# SCIENCE ADVISORY BOARD

EPA-SAB-22-001

Subject: Transmittal of the Science Advisory Board Report titled “Review of Multi-Agency Radiation Survey and Site Investigation Manual, Revision 2” (Public Comment Draft), dated May, 2020

**Figure 5.7: Gray Region for Scenario A**

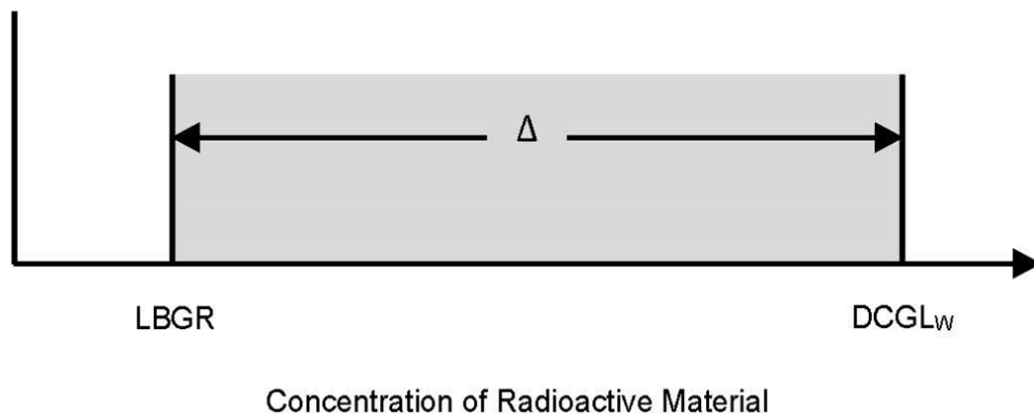
In Scenario A, the UBGR is set to the DCGL<sub>w</sub> [above see Figure 5.7 of the draft MARSSIM Revision 2 (U.S. EPA, 2020)] and it is suggested that the LBGR be set to a conservative (high-sided) estimate of the amount of residual radioactivity. This requires some knowledge (necessarily uncertain) about the true concentration levels of the site, and how they differ from baseline measurements, as well as the variability of the measurements of concentrations that will be encountered during the actual study. In some cases, this information is available from earlier surveys; in other cases, expert opinion may be all that can be relied upon (see response to Charge Question 3.1). A problem with using Scenario A arises when the DCGL<sub>w</sub> is set to nearly zero, implying that essentially no increased concentration is permitted. In this case, the necessary sample size for collection and analysis can become unreasonably large and infeasible, since the relative shift approaches zero. Setting DCGL<sub>w</sub> to nearly zero typically implies very small doses and risk from the contaminant, but it could be noted more clearly in the guidance that simply switching from Scenario A to Scenario B doesn't solve this problem, the gray region must be expanded before sample sizes become feasible. The concepts of discrimination limit (DL) and action level

Page 5-28, Figure 5-7, Gray Region for Scenario A: The meanings of the abbreviations LBGR and  $DCGL_w$  should be added as footnote to the figure.

**Figure 5.8: Gray Region for Scenario B**

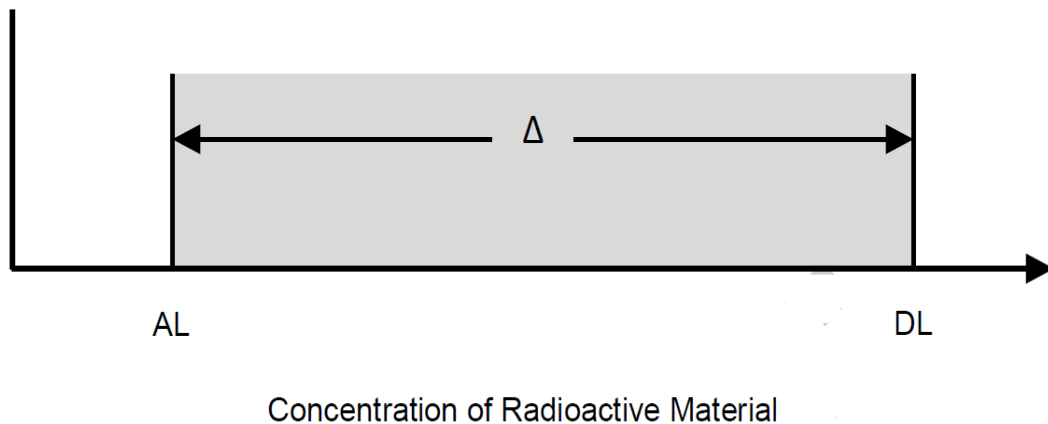
(AL) also need explanation as these are the UBGR and the LBGR respectively under Scenario B [above see Figure 5.8 of the draft MARSSIM Manual (U.S. EPA, 2020)]. The requirement (in order to avoid an “owner-friendly” bias) for retrospective power analysis when the null hypothesis is not rejected under Scenario B should be introduced to provide additional support that successful remediation was based on a robust and defensible decision-making process.

Page 5-29, Figure 5-8, Gray Region for Scenario B: The meanings of the abbreviations AL and DL should be added as footnote to the figure.
